SERVICE BULLETIN

SB1227

ADDRESSEES	: Owners and operators of coaches listed under 'Application'
COACH/BUS MODEL	: TD925US, C2045, T2100 Series
BULLETIN TYPE	: Service Information
MANUAL	: Maintenance Manual
SECTION/CHAPTER	: Electrical system
DATE	: March 13, 2009
SUBJECT	: Engine mounted alternator – mounting bracket fastener retention check
TERMS & CONDITIONS	: Should repairs be necessary, the regular terms and conditions apply for units covered by the Van Hool normal warranty.

To improve the retention of the alternator mounting bracket

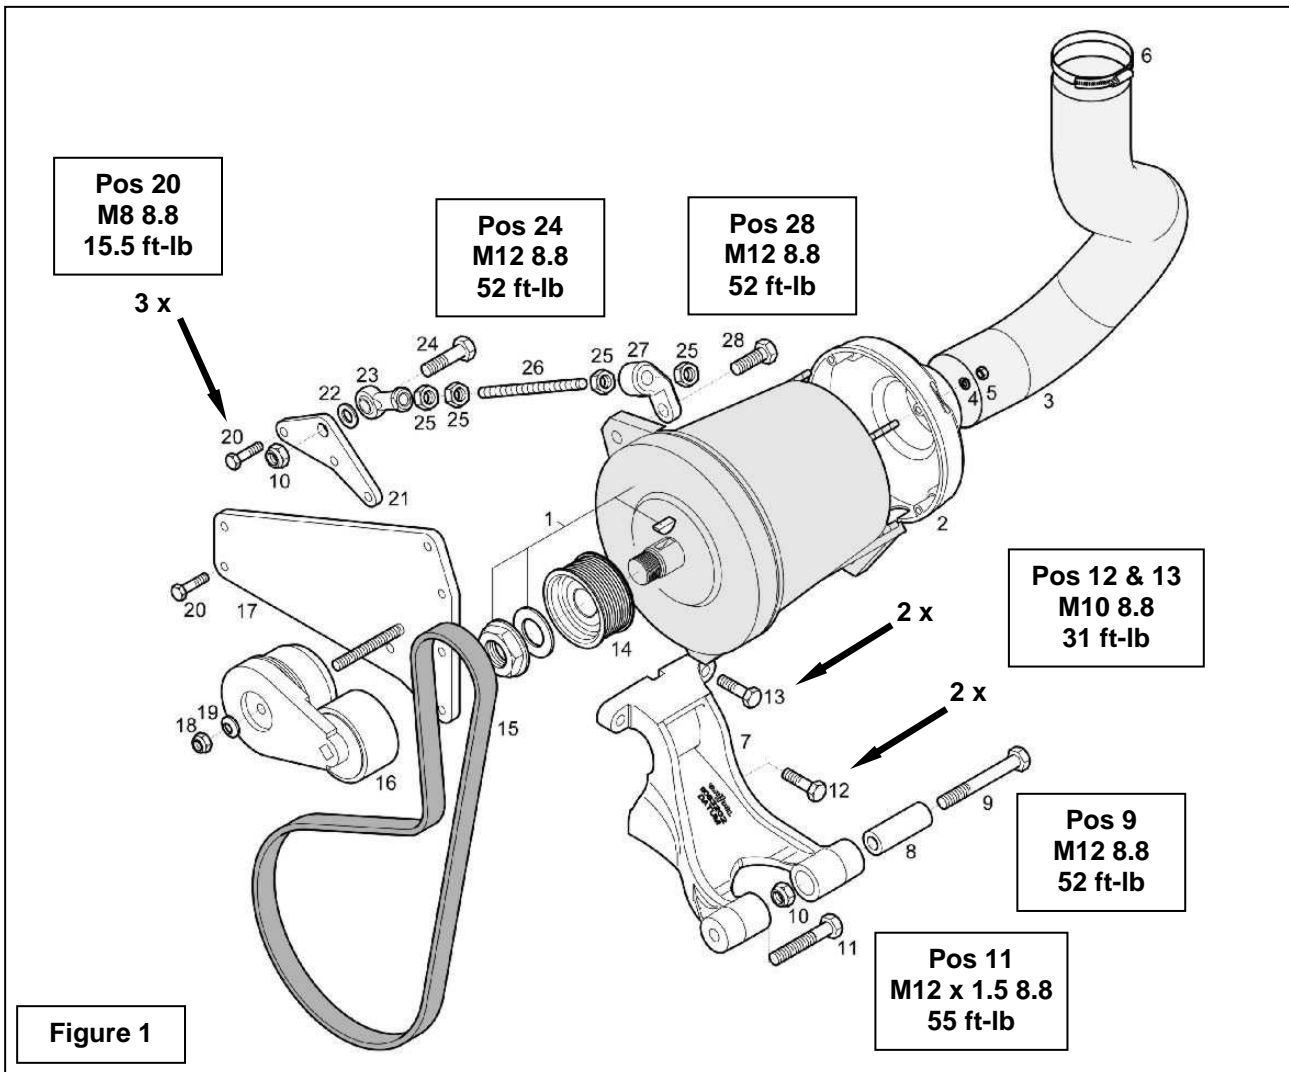
1. It has been determined that on a number of occasions the fasteners securing the alternator mounting brackets to the engine (arrows, Figure1) had worked loose as a result of vibrations.
2. To address the issue it is necessary to check fastener retention during the next service interval at the latest in order to ensure system performance.
3. Please refer to the procedure below for further instructions.
4. If the fastener retention check fails the test described in this Service Bulletin, please follow the instructions outlined in the attached Work Procedure WP573 "To improve the retention of the alternator mounting bracket".

- 2) Slacken the turnbuckle adjuster.
Undo and remove the fasteners securing the alternator upper ear to the turnbuckle adjuster (position 28, Figure 1).
- 3) Slacken the fasteners securing the lower alternator pivots to alternator bracket #11063204 (positions 9 and 11, Figure 1).
Swing the alternator away from the engine.
- 4) Refer to the OE fastener torque reference chart and to Figure 1.

- 5) Using a 3/8 drive flex ratchet torque wrench check that the fasteners securing the alternator mounting brackets (positions 12, 13, 20, Figure 1) to the engine are still properly tightened.

- 6) Check that the through bolt of turnbuckle adjuster ball joint (position 24, Figure 1) is torqued to 52 ft-lb.
- 7) If the fastener retention complies with the specifications, reinstall the alternator and drive belt referring to the Maintenance Manual:

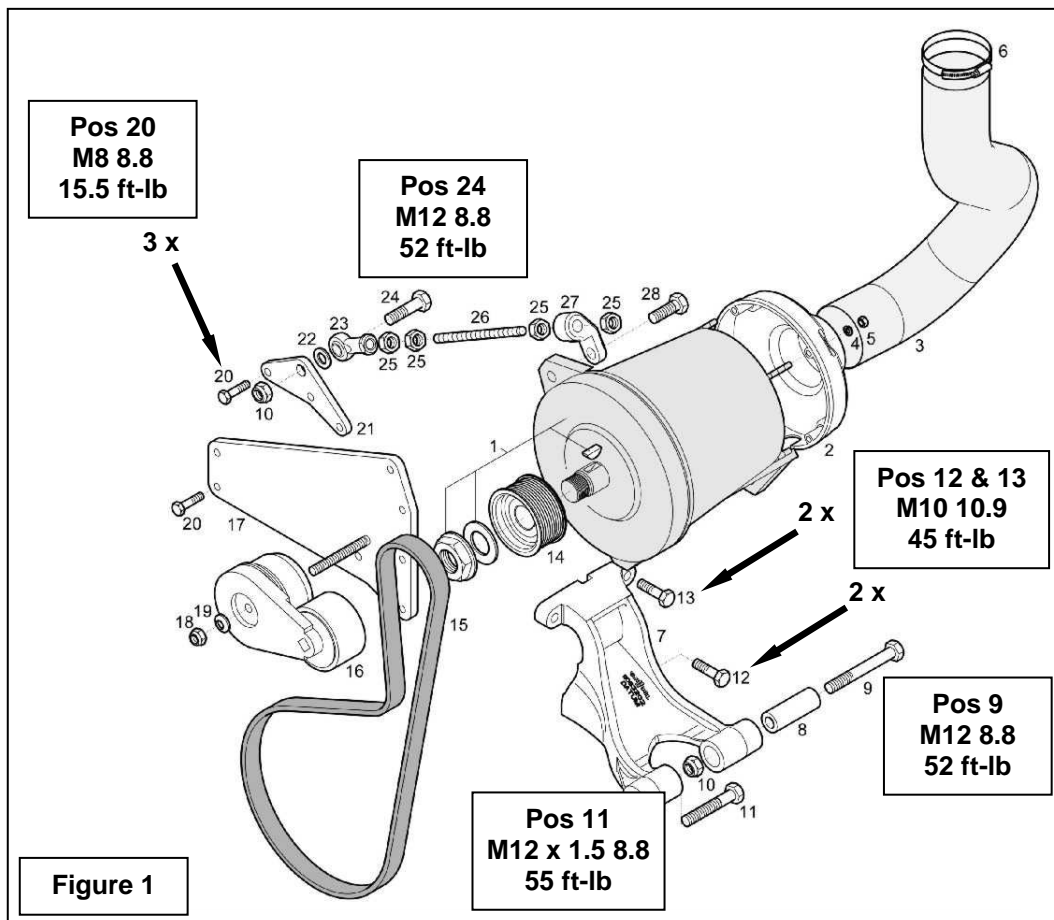
1. It has been determined that on a number of occasions the fasteners securing the alternator mounting brackets to the engine (arrows, Figure1) had worked loose as a result of vibrations.

Reference	Description	Qty.	Refer to
VH 660224503	Bolt, M10 x 1.5 x 30 mm, grade 8.8, DIN 933	2	12, Figure 1
VH 660224601	Bolt, M10 x 1.5 x 35 mm, grade 8.8, DIN 933	2	13, Figure 1
VH 660629103	Washer, 13 x 24 x 2.5 mm, DIN125	1	22, Figure 1

Reference	Description	Qty.	Refer to
VH 11149701	Bolt, M10 x 1.5 x 30 mm, grade 10.9, DIN 933	2	12, Figure 1
VH 10527474	Bolt, M10 x 1.5 x 35 mm, grade 10.9, DIN 933	2	13, Figure 1
VH 10580793	Washer, Belleville spring lock, Nomel 551241, class E, for grade 10.9 M12 bolts, 24.3 mm outer diameter, 1.6 mm thick	2	Figure 4
VH 10718745	Thread locker, Loctite 243 (medium strength)	#	N/S

- Referring to the repair fastener torque reference chart, replace the OE fitted grade 8.8 bolts by 10.9 grade M10 x 1.5 bolts.
Upper mounting bolts should be 35 mm long, the lower ones 30 mm (12 and 13, Figure 1).
- Check the depth of threaded holes in the engine block first in order to make sure that the bolts don't bottom out.
- If necessary use hardened flat washers to adjust thread length.
- As a safety measure apply a dab of Loctite 243 thread locker (medium strength) on the threads.
- If there is any damage to bushing 11063465 (8, Figure 1) or bolts 660246505 (9, Figure 1) and 660251045 (11, Figure 1) replace these as a matter of course.

Alternator bracket 11063204

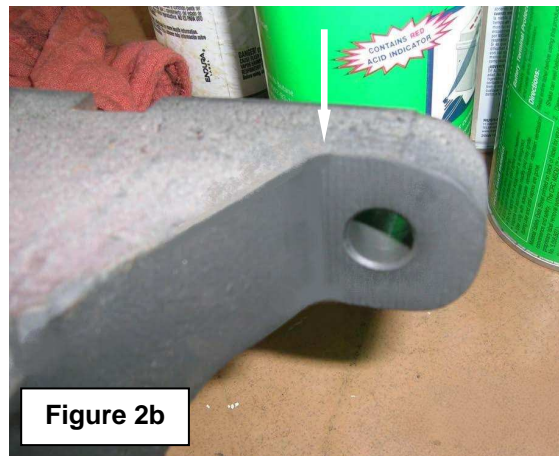
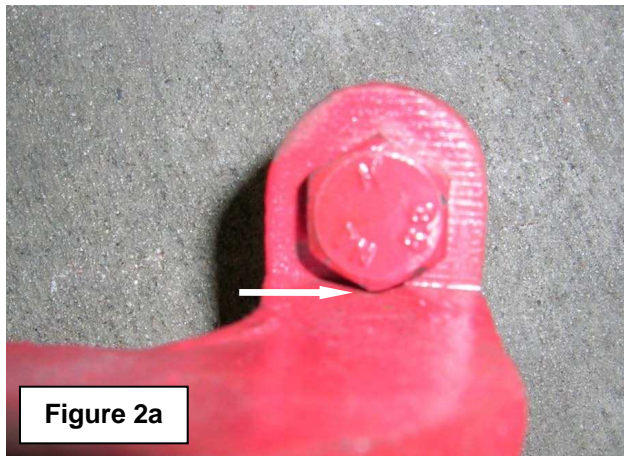
Whenever the location of the mounting bolt through holes in the pads does not permit the fitment of a socket over the bolt head the pad faces should be enlarged by grinding to accept one (Figures 2a through 2d).

Take care to provide an ample radius between the pad and the bracket body in order to prevent notching (Figure 2b).

Do not undercut and avoid sharp edges and grooves as these will start cracks.

Make sure the mating face for the bolt head is dead flat.

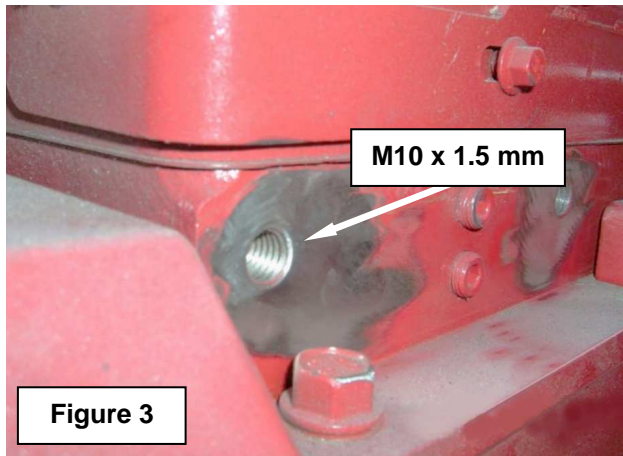
- The bracket pad and engine mating faces should be true and clean and free of paint and debris (Figure 3).
Clean the threaded holes in the engine block with An M10 x 1.5 mm thread chaser, then remove all debris from them with compressed air (Figure 3).

Turnbuckle adjuster bracket 11043715, coolant tube bracket 11088950, ball joint 634303230, flat washer 660629103

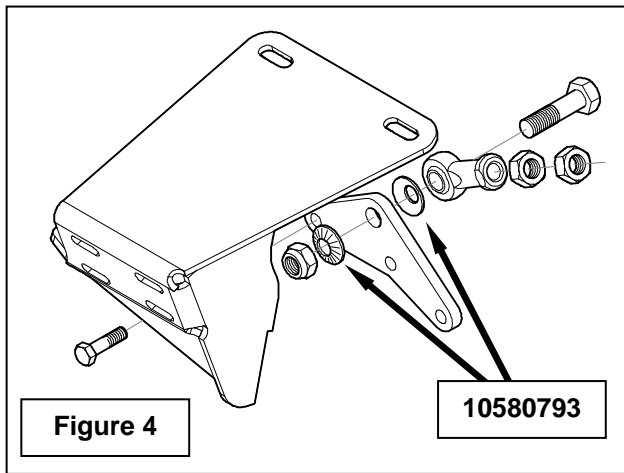
- Referring to the repair fastener torque reference chart, use new bolts 660222503 (M8 x 1.25 x 30 mm, grade 8.8, DIN 933) to secure these brackets to the engine.

- Check the depth of threaded holes in engine block first in order to make sure that the bolts don't bottom out.
If necessary use hardened flat washers to adjust thread length.

- As a safety measure apply a dab of Loctite 243 thread locker (medium strength) on the threads.
- The mating faces of these brackets and of the engine should be true and clean and free of paint and debris.

- Clean the threaded holes in the engine block with a thread chaser, then remove all debris from them with compressed air.
- When attaching the turnbuckle adjuster ball joint to bracket 11043715, use a new bolt 660226801 (M12 x 1.75 x 45 mm, grade 8.8, DIN 933) and lock nut 660207406 (M12 x 1.75, grade 8.8, DIN 980).
Delete single plain washer 660629103.
Fit conical Belleville spring lock washers instead, one on each side of the bracket, as shown in Figure 4.

One washer should fit between the ball joint and the bracket with the ribbed side facing the ball joint.
One washer should fit between the bracket and the M12 lock nut with the ribbed side facing the nut.
